# INDIANA DEPARTMENT OF TRANSPORTATION

## FINAL DRAFT MINUTES

### November 18, 2010 Standards Committee Meeting (No Changes to First Draft Minutes)

RE: Minutes for the November 18, 2010 Standards Committee Meeting

PROPOSED REVISION TO 701-BPIL-05 STEEL H-PILE SPLICE PROCEDURE (DRAFT)

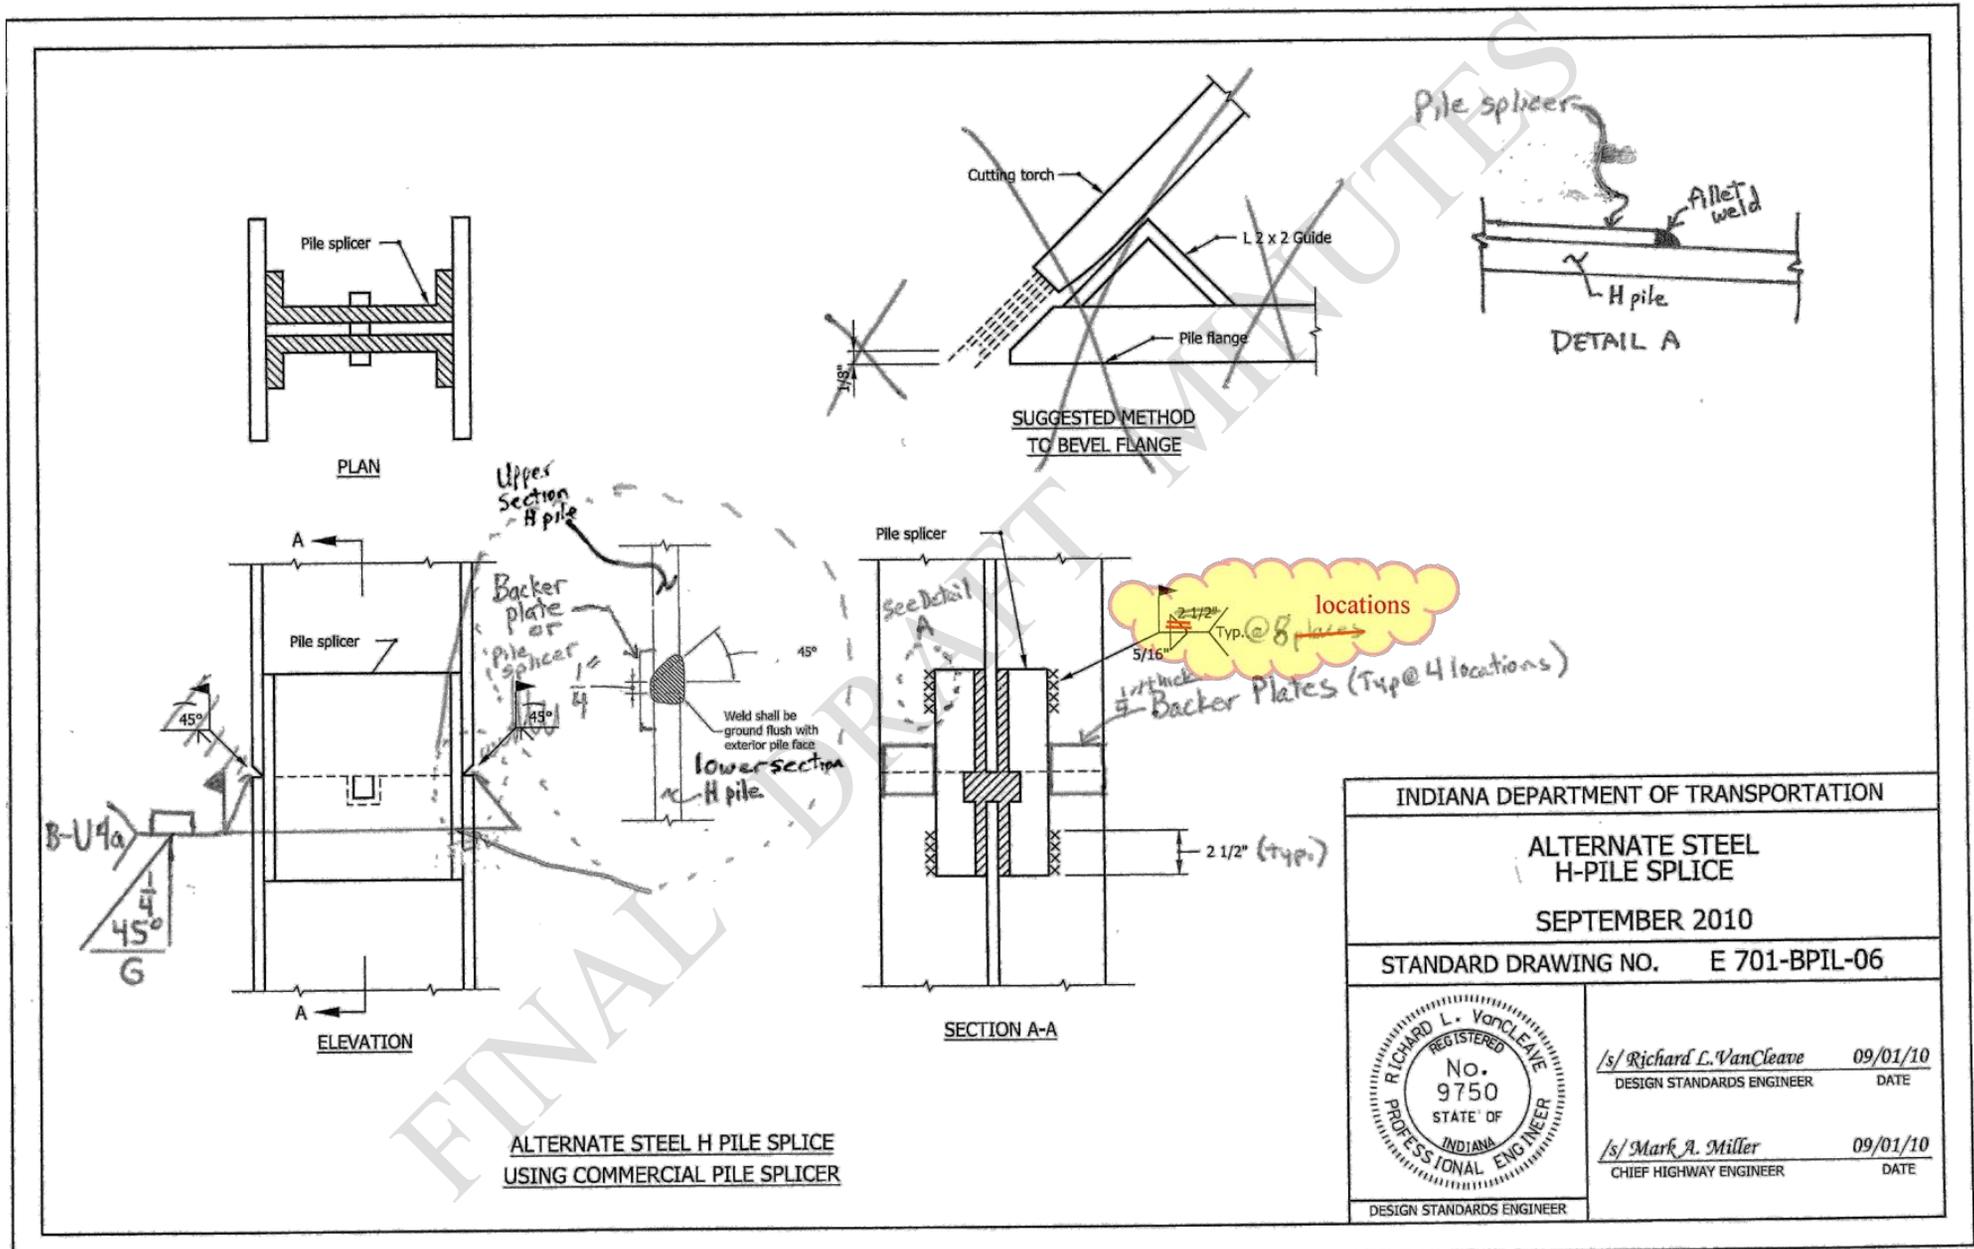
PROBLEM(S) ENCOUNTERED: The Department is having problems with pile splicing. There have been several pile splices that have failed.

PROPOSED SOLUTION: Modify standard drawings 701-BPIL-04, delete the existing standard drawing 701-BPIL-05 and replace it with a new drawing, and modify 701-BPIL-06. Also incorporate minimum preheat language into 701.11.

Mr. Reilman explained the changes they are proposing to the standard drawings shown on page 10 and 11 of the meeting agenda.

Mr. Strain inquired about the best way to illustrate the welds shown to make sure they match AWS code. Mr. Reilman said he will look into them and verify they are accurate and illustrated correctly.

Mr. Pankow made the motion to accept this proposal as revised. Mr. Cales seconded that motion. All approved.

All agreed that the proposed changes will go into the 2012 book as amended. Proposed Revised Draft drawings are included in these minutes. Changes are shown as highlighted in yellow.

PROPOSED RECURRING PLAN DETAIL 805-T-175D MICROLOOP DETECTOR PROBES CROSS SECTION DETAIL (DRAFT)

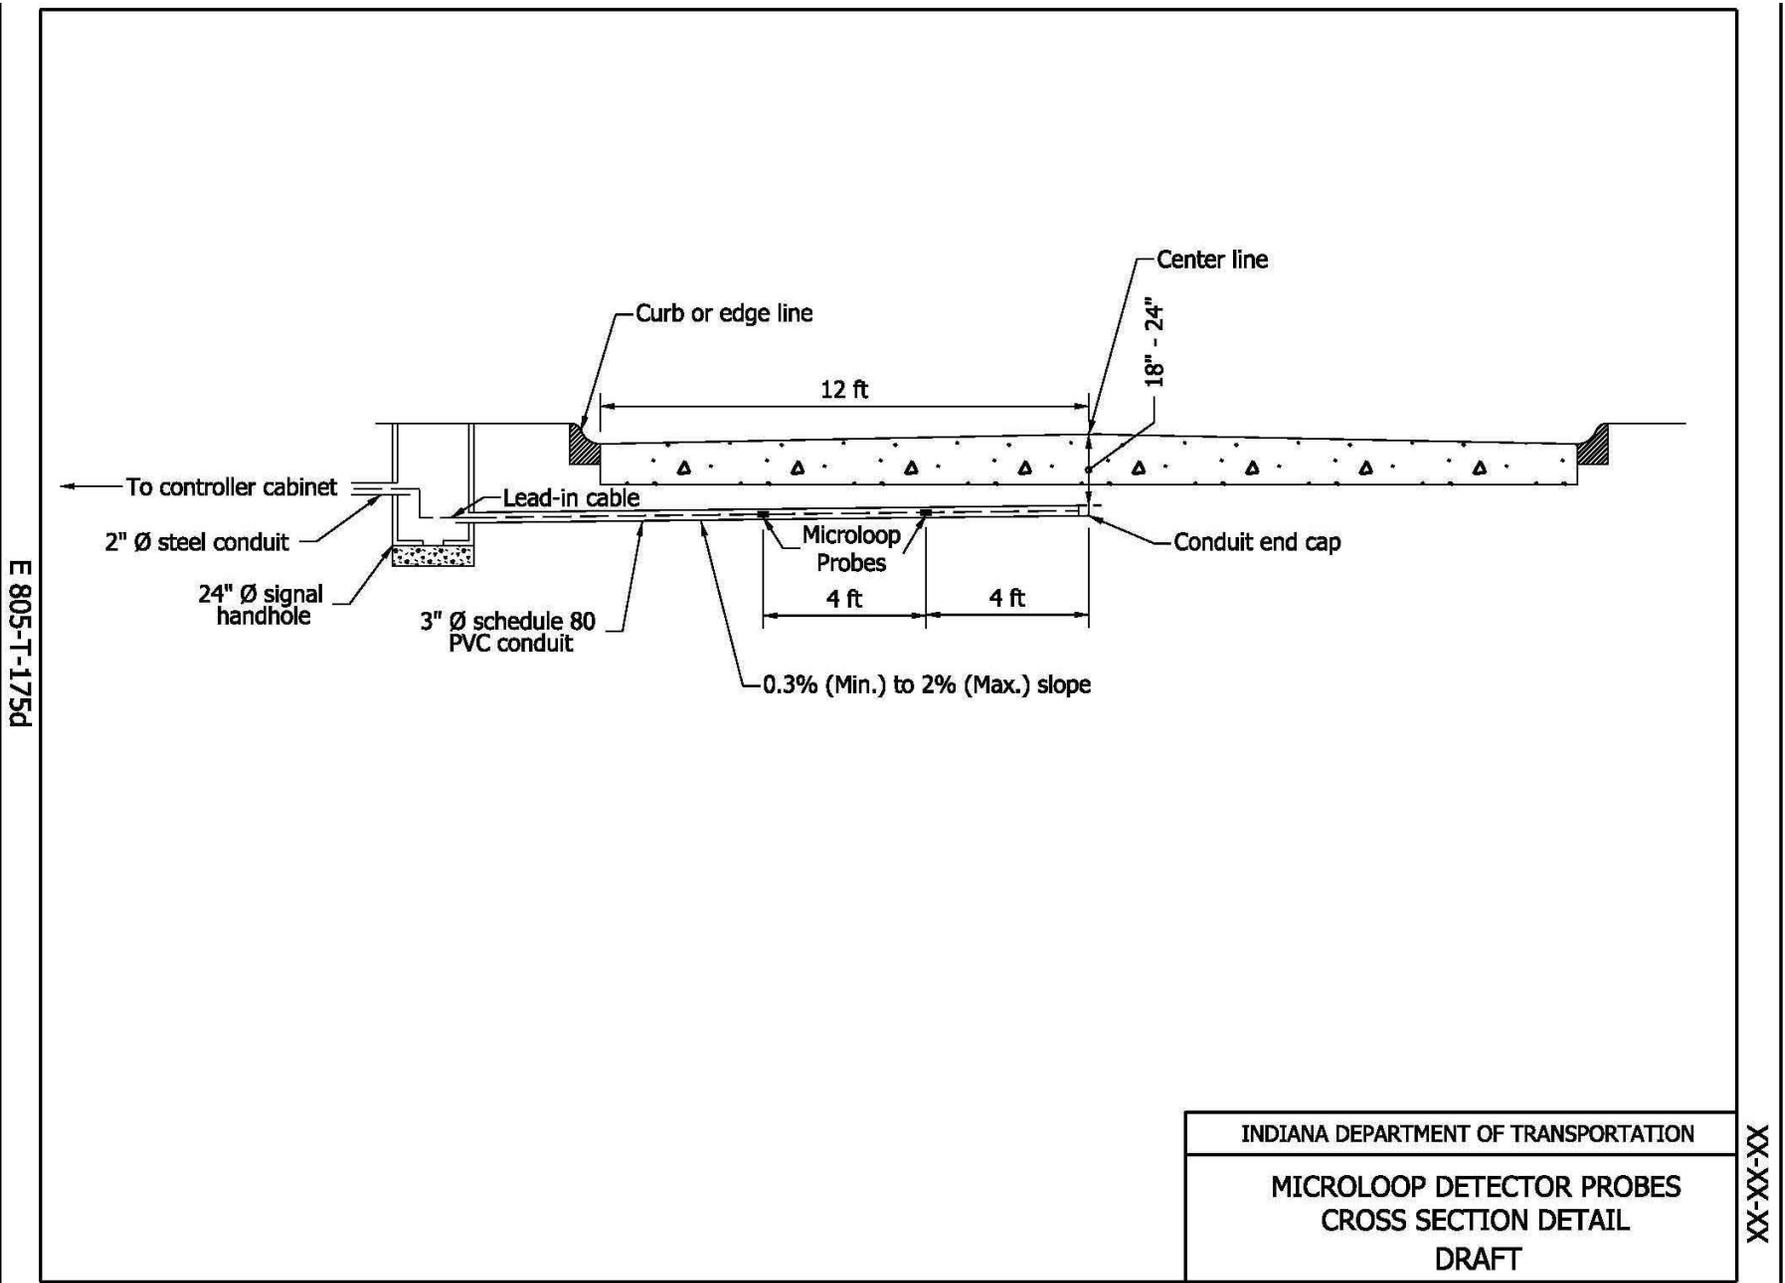
Mr. Caplinger asked about the depth of the conduit since it is inserted under the existing pavement. Mr. Andrews said it is usually bored and recommended adding language covering damaged pavement during installation.

This item was withdrawn pending further review and clarifications.
